# NOTICE OF DECISION

**CLASS 3 SITE PLAN REVIEW / CLASS 2 ADJUSTMENT CASE NO.: SPR-ADJ24-14**

**REQUEST:** A Class 3 Site Plan Review for development of a new building containing an existing general manufacturing use, Naturefts Kick Original Honeystix, with three Class 2 Adjustment requests:

IN THE MATTER OF APPROVAL OF ) FINDINGS & ORDER  
CLASS 3 SITE PLAN REVIEW )  
AND CLASS 2 ADJUSTMENT )  
CASE NO. SPR-ADJ24-14 )  
1441 45<sup>TH</sup> AVE NE ) JUNE 11, 2024

SHEET 1/1

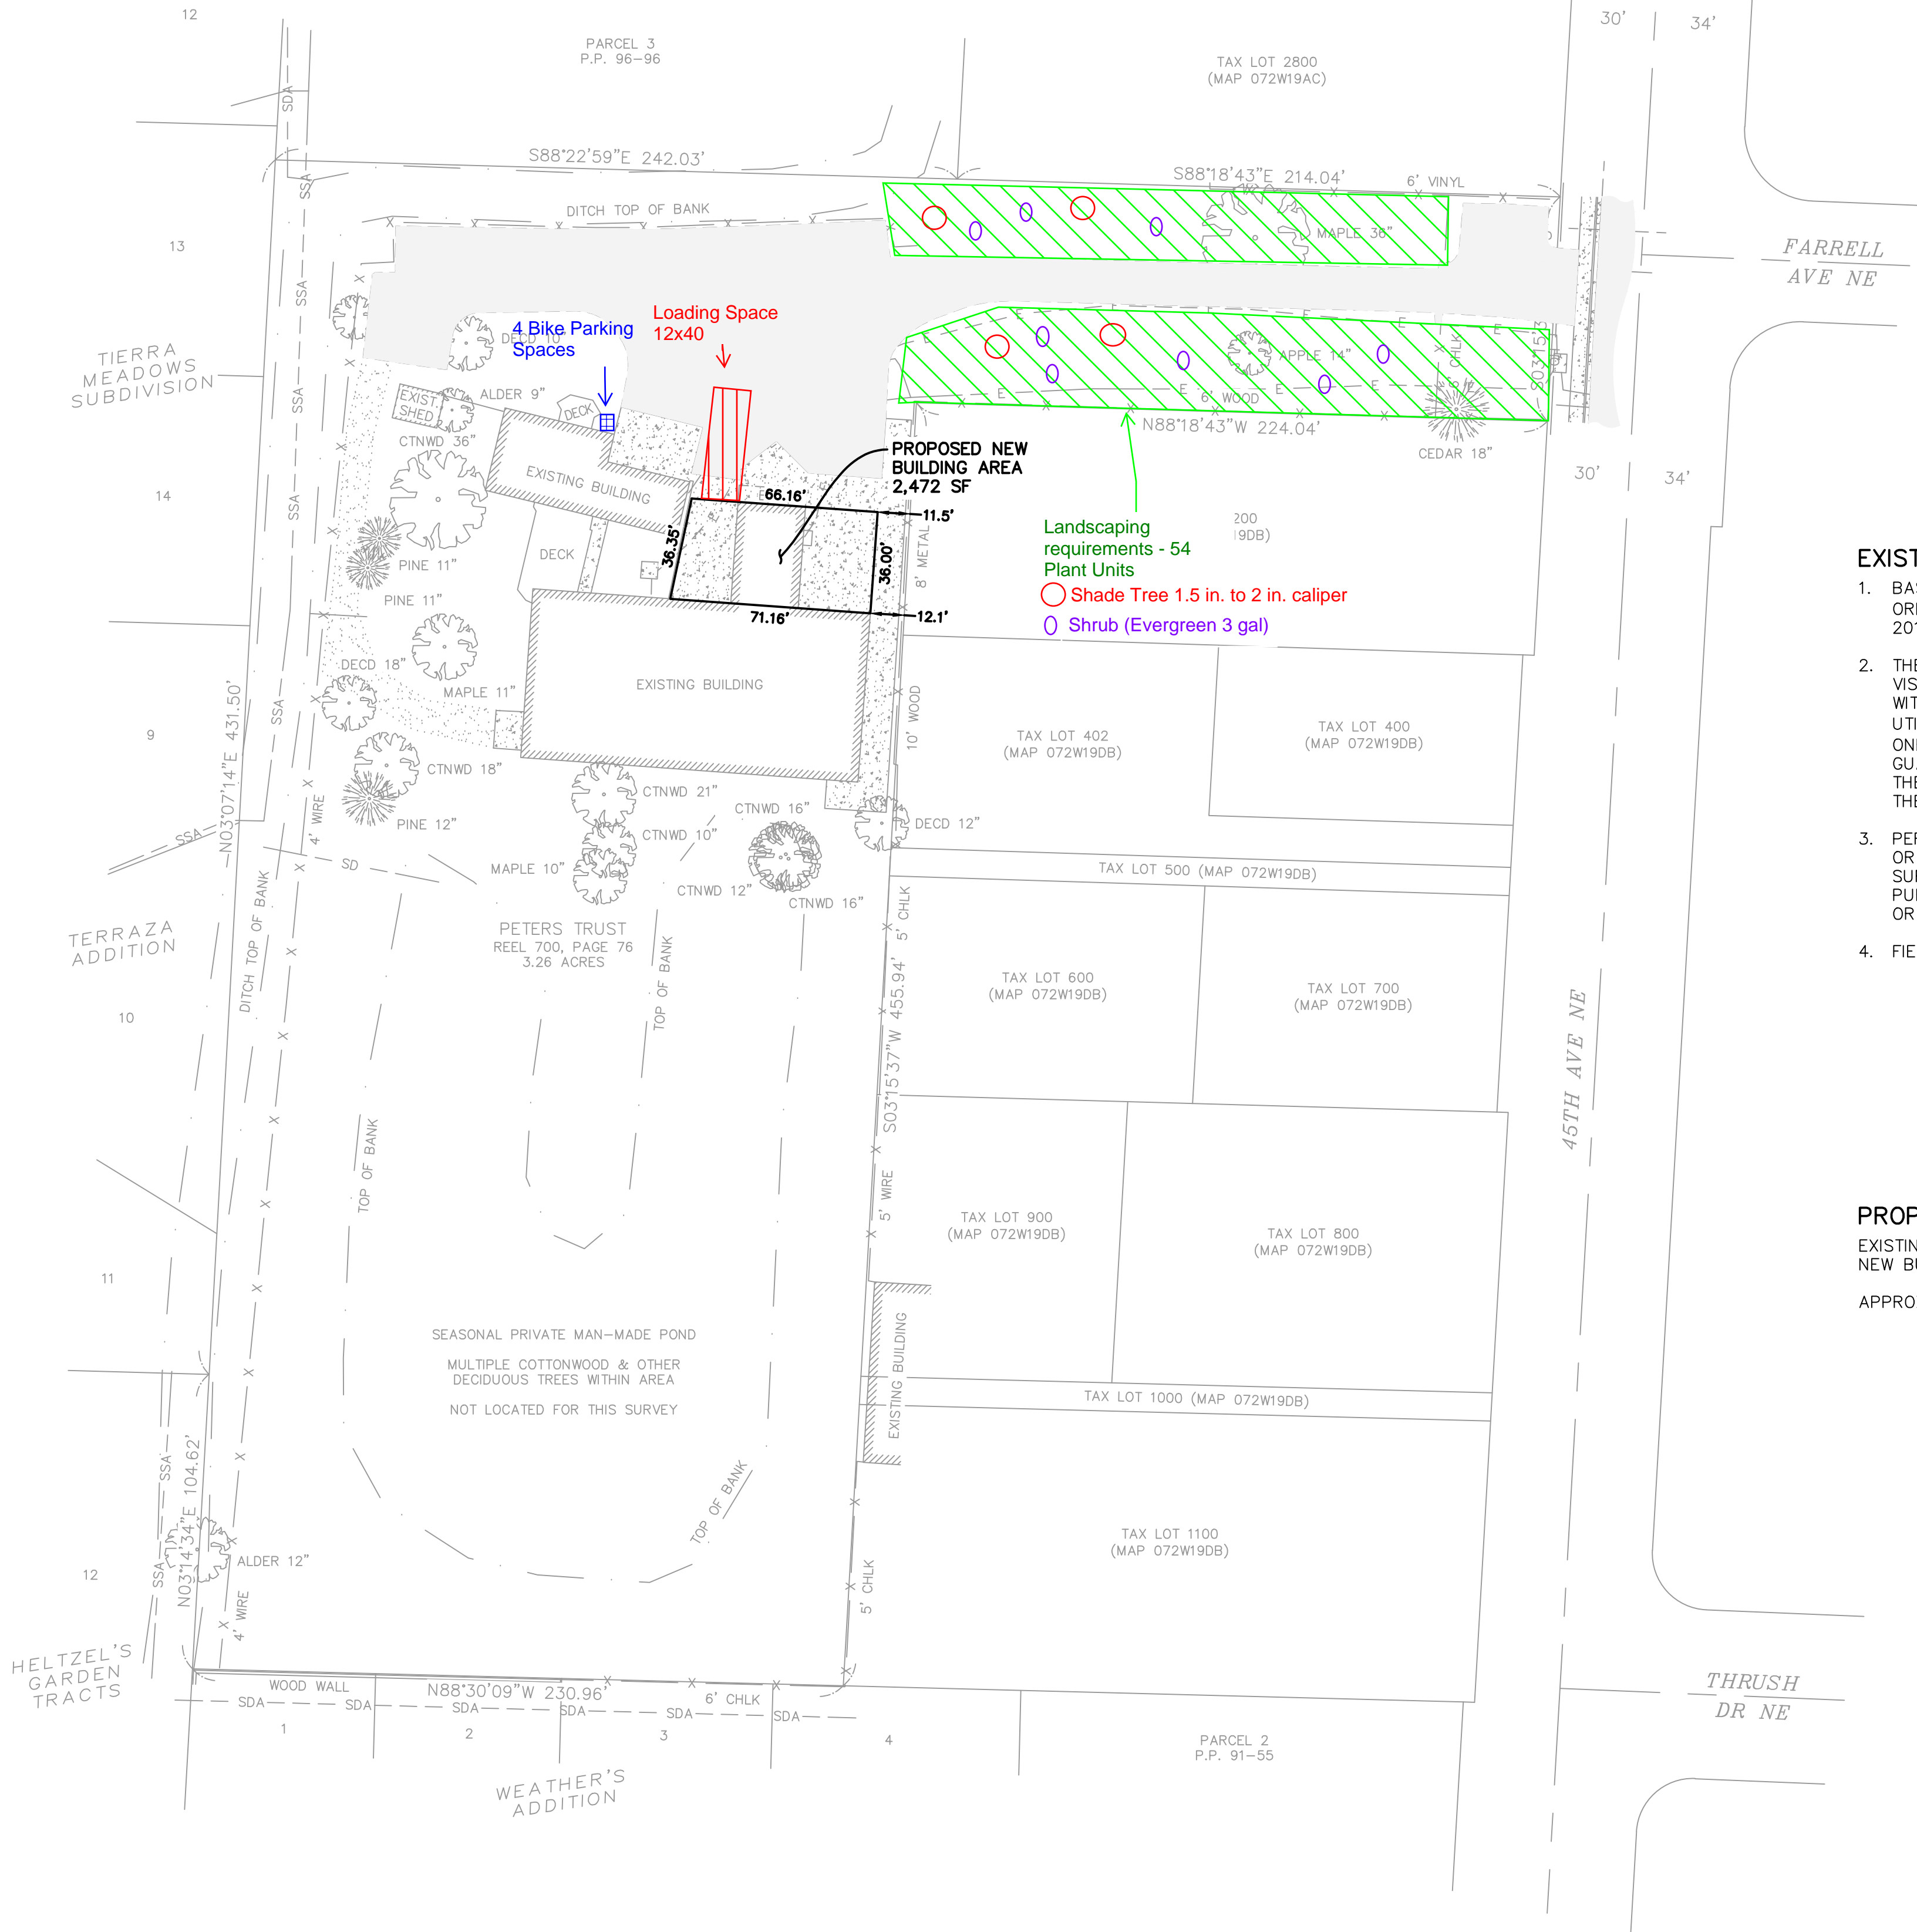
The applicant's plans do not clearly show clear compliance with Type A landscaping standards. As such, the amount of landscaping required to meet the Type A standards will be more than what is provided on the plans. To ensure that the required number of plant units will be provided at the time of building permit review, the following condition applies:

The proposal includes a new 2,472 square foot building that will be placed over an existing asphalt surface. Based on the plans submitted, it is unclear whether or not the existing asphalt will be removed, and a new foundation will be poured for the structure. However, the new or replaced impervious surface for the building subject to this site plan review is less than 10,000 square feet. Therefore, the building addition is in compliance with SRC Chapter 71 because the proposal involves less than 10,000 square feet of new or replaced impervious surface. The applicant shall be required to design and construct a storm drainage system at the time of development. The application shall provide an evaluation of the connection to the approved point of discharge for new areas of impervious surface per SRC 71.075.

There is approximately 2,900 square feet of asphalt surface that was added to the subject property without permits between 2022 and 2023 according to aerial imagery. This asphalt surface is within a City-owned maintenance and drainage easement for the West Fork of the Little Pudding River which abuts the northern line of the subject property. Pursuant to SRC 75.050(b)(A) an Erosion Control Permit is required for work that involved disturbance of more than 1,000 square feet of land. It is recommended that at time of Building Permit Review, a retroactive permit for this work be included in the scope of the building permit for civil site work.

The applicant is seeking a Class 2 Adjustment to eliminate the landscaping standard along the property's eastern boundary specifically for the extent of the new addition. The applicant's plans and written statement indicate that the area is currently surfaced and an eight-foot fence lines the eastern boundary screening the neighboring properties. The length of the eastern boundary with the proposed development is approximately 36 feet, requiring a minimum of 198 plant units ( $36 \times 30 = 1,080$  sf.  $1,080 / 20 = 54$ ). To retain the existing surfaced area and provide additional landscaping within the most visible portion of the development, the applicant has proposed to install the equivalent amount of plant units within the flag lot's pole. The existing eight-foot fence provides separation of the uses with the proposed landscaping in the flagpole providing extra screening of the activities of the site from the right-of-way. The following condition of approval shall be required to ensure the landscaping is provided within the flagpole portion.

**Condition 2:** At the time of building permit review, the applicant shall provide a full landscape plan demonstrating how the development site meets Type A landscaping, including all new and existing landscaped areas, by providing a minimum of one plant unit per 20 square feet, with 40 percent of the plant units being trees.

**Condition 3:** At the time of building permit, a minimum of 54 plant units shall be proposed within the flag lot's pole in addition to the existing landscaping.
